BEFORE THE PUBLIC UTILITY COMMISSION

Docket No. LC 80

2023 Clean Energy Plan and Integrated
Resource Plan.

OPUC Staff Opening Comments

Figure 3. Staff’s preliminary hourly dispatch simulation of the Preferred Portfolio under Reference Case conditions

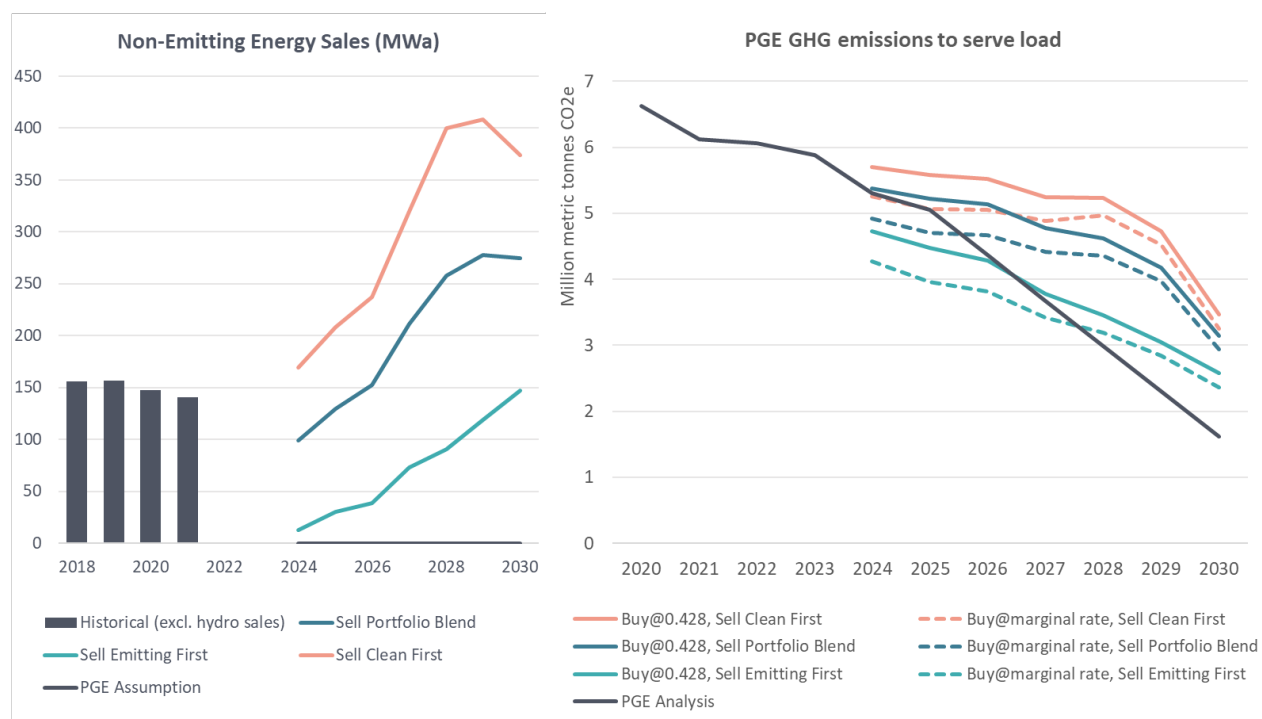
Staff’s preliminary analysis suggests under-accounting for non-emitting resource sales and underestimating portfolio GHG emissions may be a major vulnerability in PGE’s emissions reduction strategy (See Figure 1). Staff found that PGE’s GHG emissions estimates in the mid-2020s may be reasonable, but by the late 2020s, GHG emissions from the Preferred Portfolio could be well above PGE’s estimates even under the most optimistic assumptions regarding sales (i.e., that it is able to preferentially sell emitting generation).⁸

If PGE’s Preferred Portfolio is not physically able to meet its GHG targets, Staff is concerned that PGE may require more resources to meet the 2030 GHG targets than are in the plan. In particular, PGE’s plans may need more clean energy during hours when the portfolio is not long to the market—for example, some combination of energy efficiency, complementary renewable energy, and energy storage to bring more clean energy to PGE loads.

Recommendation 2: Conduct hourly dispatch analysis of the Preferred Portfolio under Reference Case conditions; discuss the results and provide relevant workpapers with PGE's Reply Comments. PGE should conduct this analysis in a manner that ensures load balance in each hour and that tracks hourly dispatch, variable costs, and GHG emissions by resource as well as hourly market purchases and market sales. PGE should also report annual portfolio costs and GHG emissions based on this simulation and that PGE provide transparency into how purchases and sales affect the GHG emissions associated with meeting load.

Figure 4. Cumulative NPVRR and GHG emissions results of portfolio analysis by CBRE portfolio26

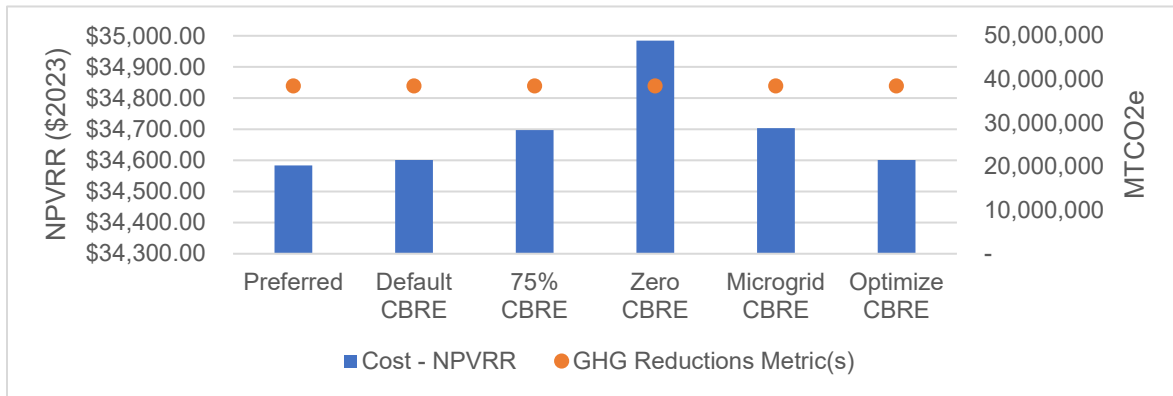
As shown in Figure 4, PGE's portfolio analysis suggests that acquiring CBREs up to the projected potential lowers overall portfolio costs compared to portfolios with reduced or no CBREs, including in the Optimize CBRE run. While PGE identified a meaningful CBRE potential level and useful portfolios to test, this analysis does not appear to provide any insights about CBREs.

First, the portfolio analysis does not appear to provide insights into the ability of CBREs to offset thermal resources. PGE’s portfolio optimization allows CBREs to compete with supply side resources, as illustrated in Figure 4, the emissions profile of the portfolio with zero CBRE acquisition, and the portfolios that acquire all available CBRE result in identical annual emissions.

During the development of near-term CEP guidance, Staff believed that including CBREs in portfolio analysis would help satisfy the HB 2021 requirement to, “[e]xamine the costs and opportunities of offsetting energy generated from fossil fuels with community-based renewable energy.”²⁷ PGE’s modeling approach answers part of this question by allowing CBREs to help contribute to GHG emission reductions, the Company does not appear to have provided analysis that allows the existence of CBREs to directly impact the dispatch of emitting resources or understand how that changes costs, risks and benefits of the portfolio. Staff will consider this issue when reevaluating the Commission’s planning and procurement policies in 2024, but Staff also expects PGE to submit a supplemental analysis with its reply comments that better addresses the statutory requirement.

Recommendation 7: In its Reply Comments, PGE should provide a supplemental analysis that satisfies the HB 2021 requirement to examine the costs and opportunities of offsetting energy generated from fossil fuels with community-based renewable energy.

Figure 6: Comparison of PGE's forward market prices from previous IRP filing to current CEP/IRP⁴¹

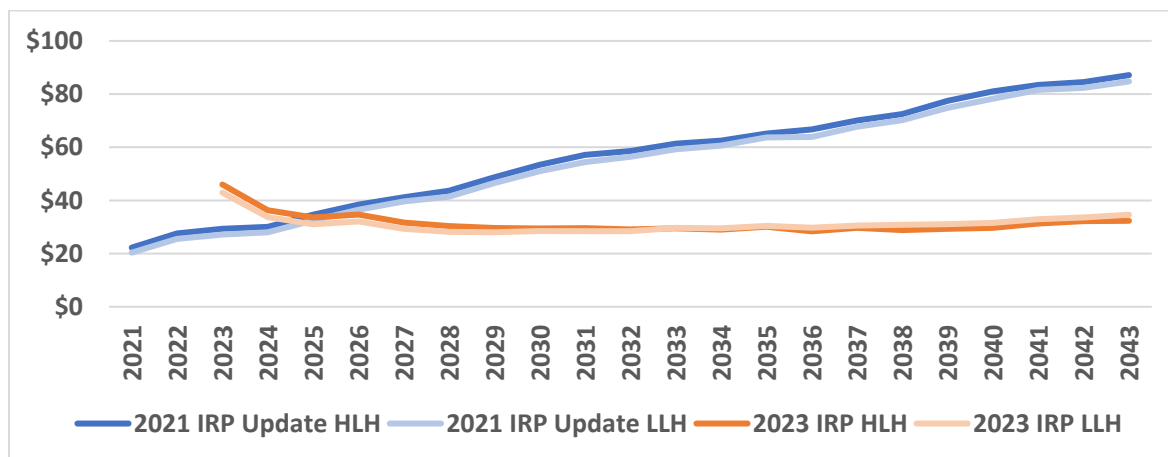
At the June 13, 2023, Special Public Meeting and in Round 0 Reply Comments, PGE stated that the avoided costs of this IRP/CEP will be used by ETO in the budgeting once the IRP/CEP is acknowledged.³⁹ However, Staff has not seen evidence that appropriate avoided costs are available as an outcome of this IRP for the proper valuation of energy efficiency. It is unclear how PGE evaluated the benefits associated with carbon reductions and avoided clean energy purchases from EE resources. PGE's IRP/CEP assumes no additional cost of carbon compliance in Oregon over the planning horizon. In response to Staff's questions on including clean energy in capacity and energy values, the Company cited the use of a four-hour battery in place of simple-cycle combustion turbines as a capacity resource and indicated that additional analysis needs to be done to account for clean energy in deriving energy values.⁴⁰

Figure 7: Staff’s analysis of PGE’s transmission rights implied by the Preferred Portfolio through 2030

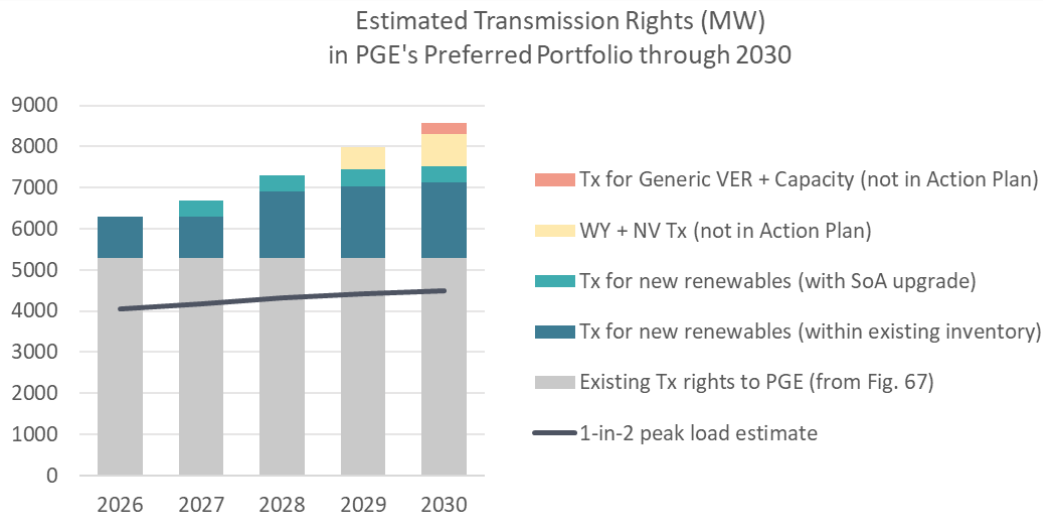
Figure 4 shows Staff’s estimate of the total amount of transmission rights implied by PGE’s Preferred Portfolio through 2030, broken out by existing merchant rights, rights for new renewables that are within PGE’s estimates of BPA’s long-term firm and conditional firm inventories, rights that could become available with PGE’s proxy transmission additions, and additional transmission rights that could be needed for off-system renewable and capacity additions.⁴⁴

Staff is also concerned that the transmission additions in the Preferred Portfolio changed so dramatically between the filed IRP and the recently filed Addendum. Specifically, the Wyoming and Nevada transmission additions through 2030 increased from 255 MW in the filed IRP to 800 MW in the Addendum, driven by updates to PGE’s load forecast. Despite how sensitive the transmission needs appear to be to the load forecast, PGE does not directly address the risk that it may have severely underestimated or overestimated future transmission needs within the plans.

Figure 8 Staff’s analysis of PGE’s transmission rights implied by the Preferred Portfolio through 2040

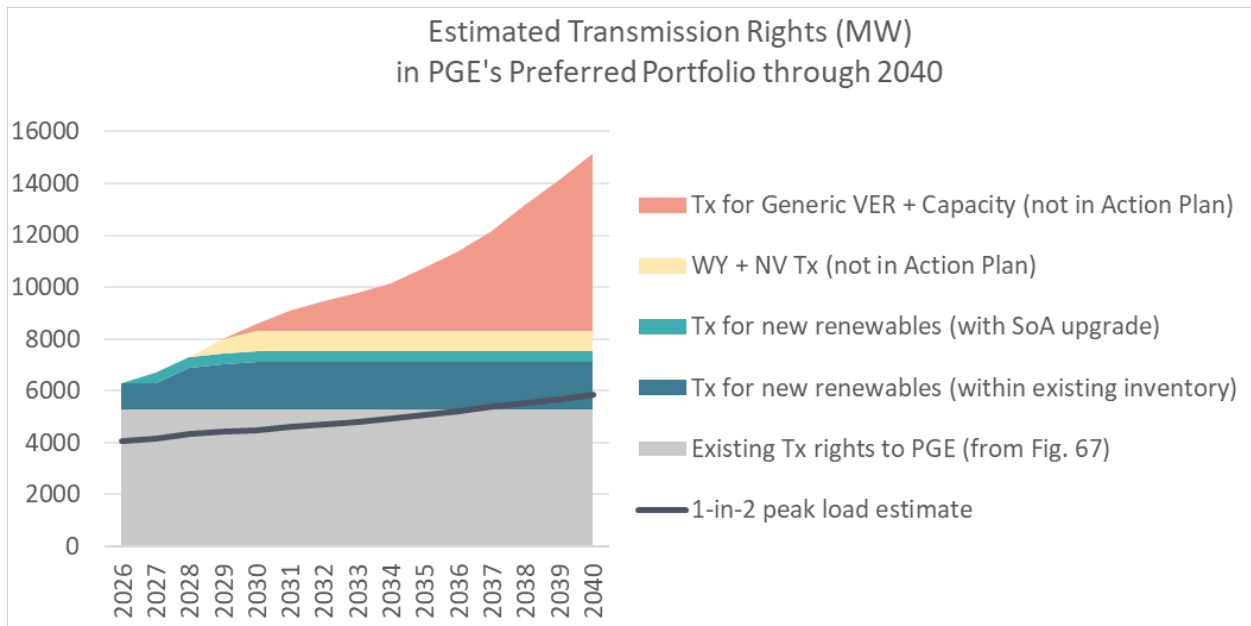
Figure 5 shows Staff’s estimation of PGE’s transmission rights implied by the Preferred Portfolio through 2040.⁵¹ Staff notes that the total transmission rights into PGE’s system will far exceed the peak demand if PGE does not materially adjust its long-term transmission strategy in the context of HB 2021.

Eventually, most of these transmission rights would necessarily go unused or be used for purposes other than serving load.

This raises several questions from Staff’s perspective: How will PGE demonstrate that accumulating these transmission rights is in customers’ interests or use excess transmission rights to directly benefit customers? What alternatives should PGE analyze to reduce costs to customers and to avoid unnecessarily over-constraining BPA’s transmission inventory? Alternative strategies could involve relying to some extent on short term firm or non-firm transmission, allowing new resources to use PGE’s existing transmission rights or to share transmission rights with other resources, allowing resources to secure transmission rights to less constrained points on the transmission system and limiting transmission rights across constrained paths based on what is needed for load service, and/or joining an RTO. All of these options could bring about new risks and Staff believes that a more rigorous understanding of these risks will support more informed planning decisions related to transmission.

Figure 13. Wind ELCC comparison between 2019 IRP Update and 2023 IRP

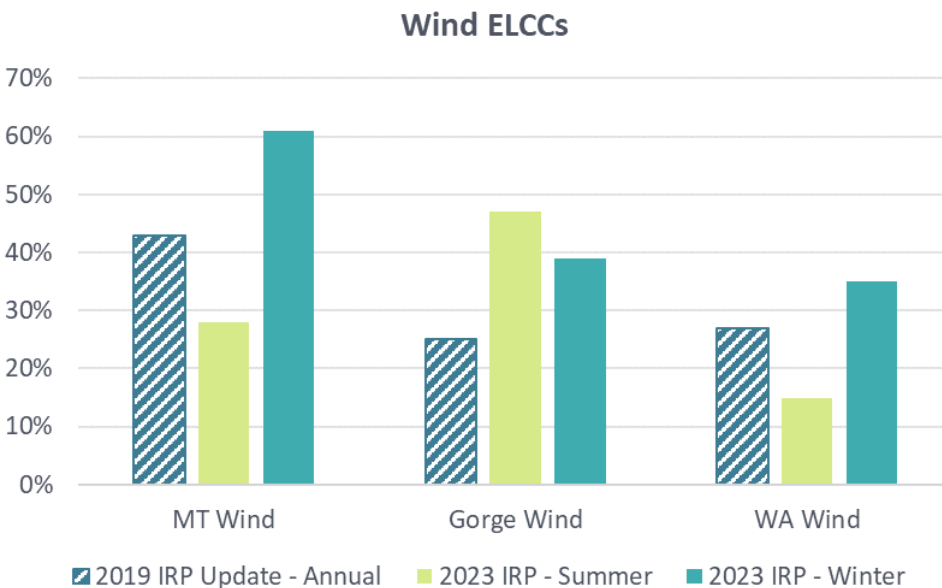
Staff is concerned that PGE’s analysis may be overestimating the capacity contribution of Gorge Wind in the portfolio analysis.

The Gorge Wind ELCC appears to be much larger than in the 2019 IRP Update (see Figure 2) and it is not clear to Staff why this would be the case. PGE indicates in its response to OPUC Data Request No. 71 that the wind shapes in Sequoia were developed using NREL’s System Advisor Model. Staff requests that PGE explain why Gorge Wind ELCCs have increased so much since the 2019 IRP Update.

Staff is also reviewing the tuned ELCCs provided in Appendix K. Staff requests that PGE provide additional discussion of why there are such large differences between the tuned ELCCs and the ELCC curves used in portfolio analysis.
